ISSUE: Permit to Demolish/Capsulate (partial) and Certificate of Appropriateness for alterations and additions

LOCATION: Old and Historic Alexandria District
Address 1404 King Street

BAR#2024-00112 & BAR#2024-00118
1404 King Street

Note: Staff coupled the applications for a Permit to Demolish (BAR #2024-00118) and Certificate of Appropriateness (BAR #2024-00112) for clarity and brevity. The Permit to Demolish requires a roll call vote.

01 SK-01a DECK GUARDRAIL SECTION DETAIL

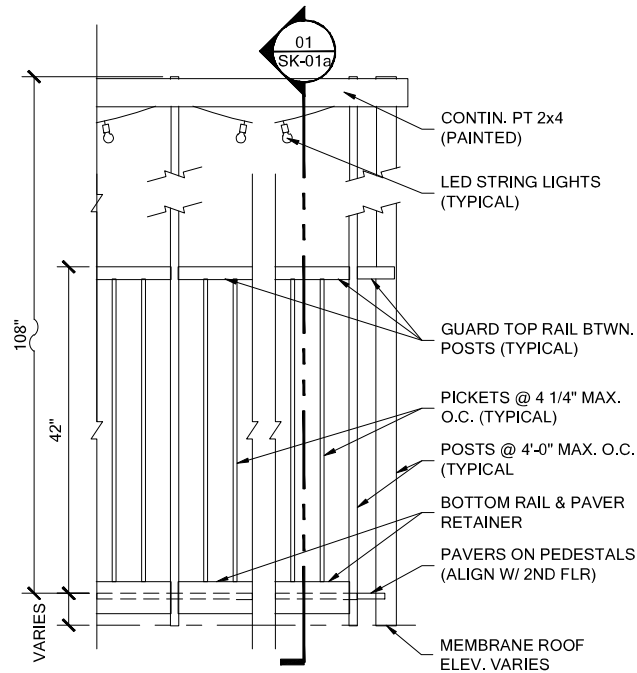
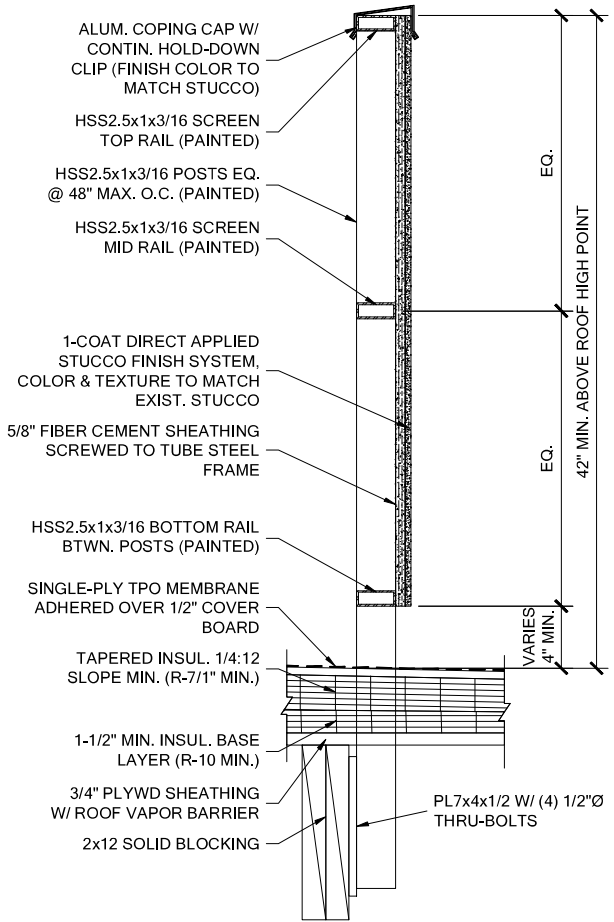
1. Cement plaster finish: Quickcrete cement plaster scratch, brown and finish coats. Color and texture to match existing at West façade.
2. Guardrails in all areas.
 - a. Rear deck: Fabricated steel bar, sizes as called out in the attached revised building elevations, building sections, and detail sketch drawings. Painted with SW 7206 Iron Ore paint finish.
 - b. Main roof: safety guard rails detail revised to add full face panels on public side with stucco finish screen walls, heights 42” unless specified otherwise on attached

01 SK-01b ROOFTOP MECH. SCREEN & GUARD
 SCALE: 1 1/2" = 1'-0"
 12 9 6 3 0 1 2

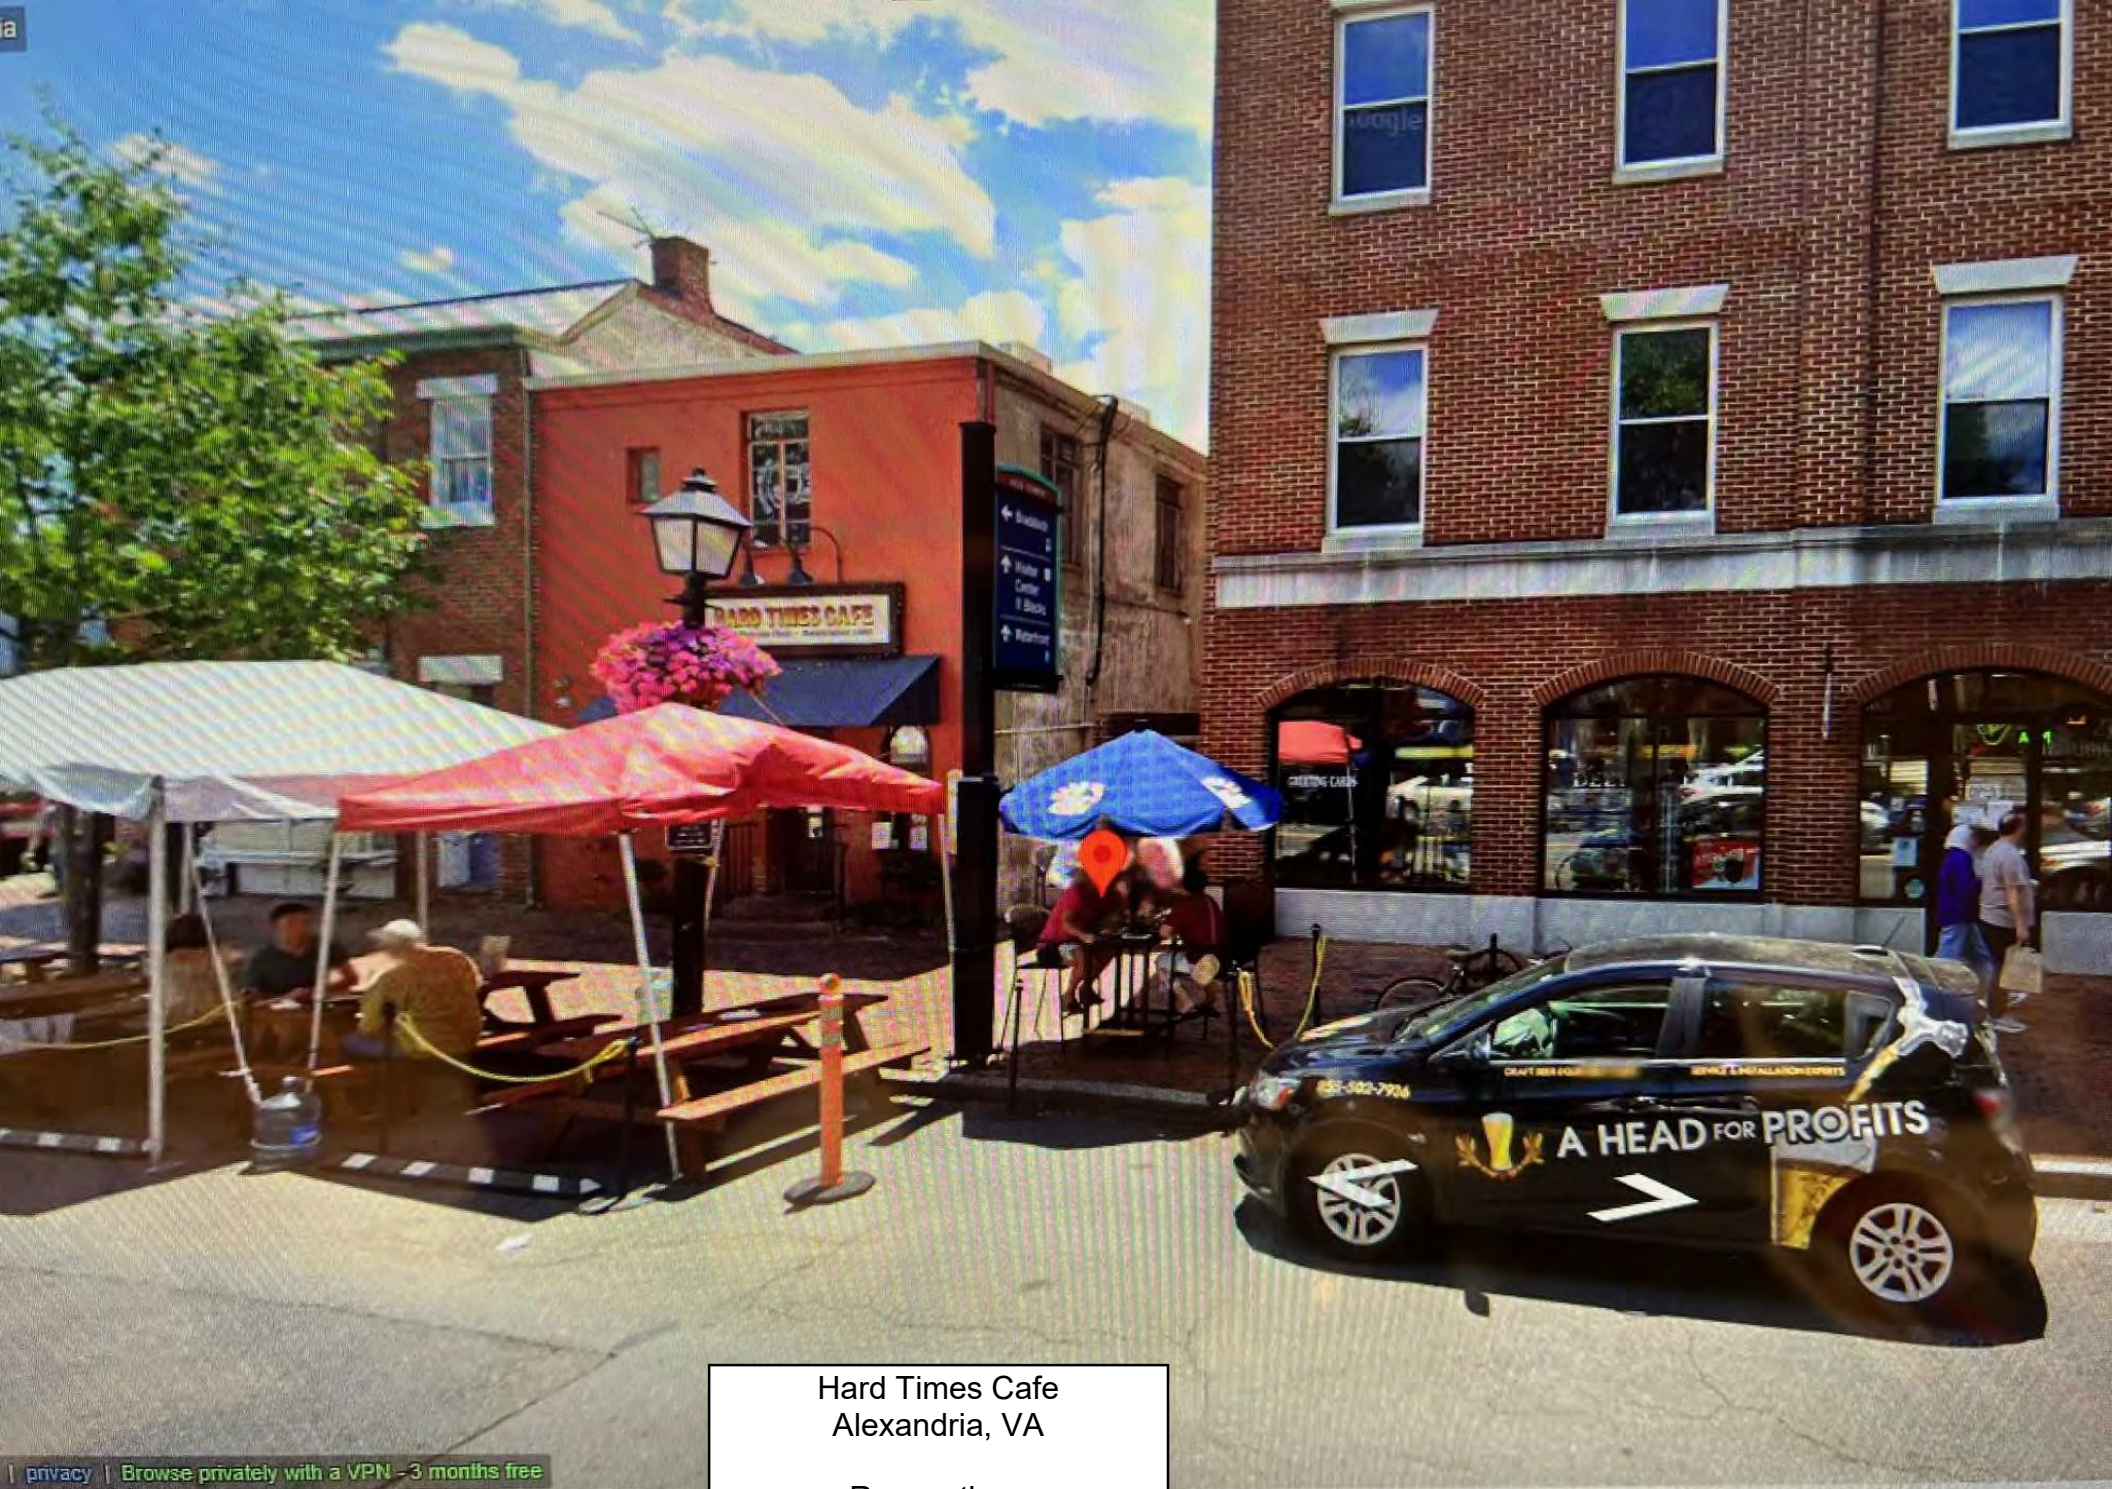
revised roof plan, building elevations, building sections, and detail sketch drawings. Roof plan indicates layout to provide screening for sight lines from public ROW Stucco to match parged/stucco color and texture on main building below.
